**SUBJECT: Docket number: 12-BTSD-06**

**Proposed Residential Manual Language Changes**

**4.5.2 Zonal Control**

Figure Error! No text of specified style in document.-1- Zonal Control Example

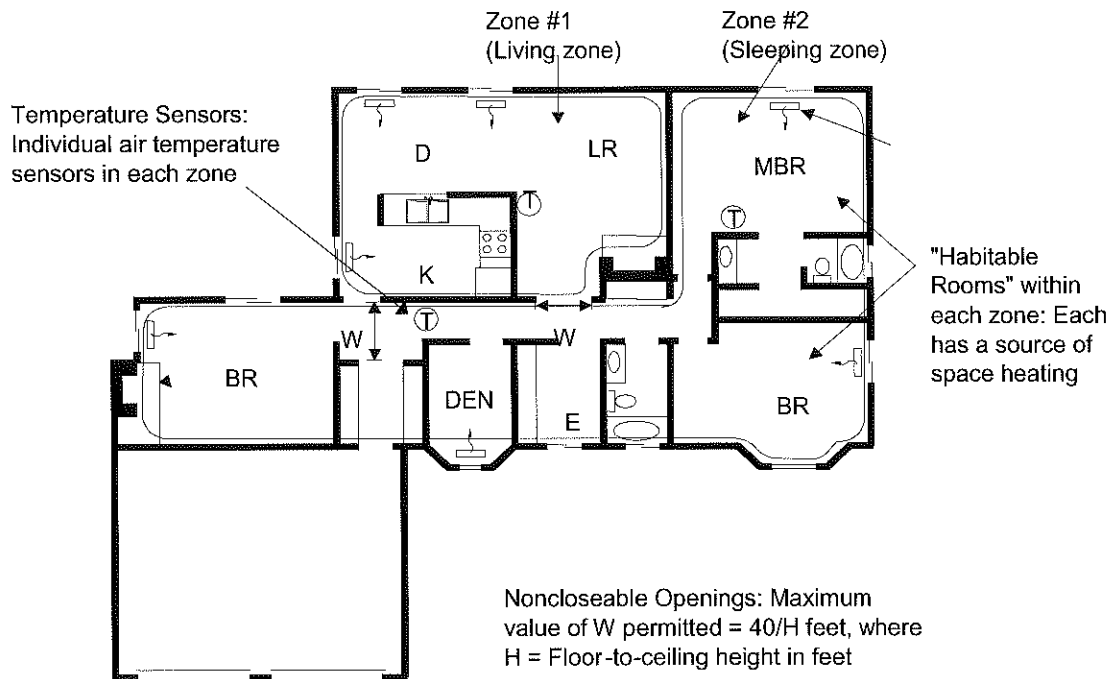
An energy compliance credit is provided for zoned heating systems, which save energy by providing selective conditioning for only the occupied areas of a house. A house having at least two zones (living and sleeping) may qualify for this compliance credit. The equipment may consist of one heating system for the living areas and another system for sleeping areas or a single system with zoning capabilities, set to turn off the sleeping areas in the daytime and the living area unit at night (see Figure **Error! No text of specified style in document.-1**).

3. **Non-closeable Openings.** The total non-closeable opening area ( $W$ ) between adjacent living and sleeping thermal zones (i.e., halls, stairwells, and other openings) must be less than or equal to 40 ft<sup>2</sup>. All remaining zonal boundary areas must be separated by permanent floor-to-ceiling walls and/or fully solid, operable doors capable of restricting free air movement when in the closed position.
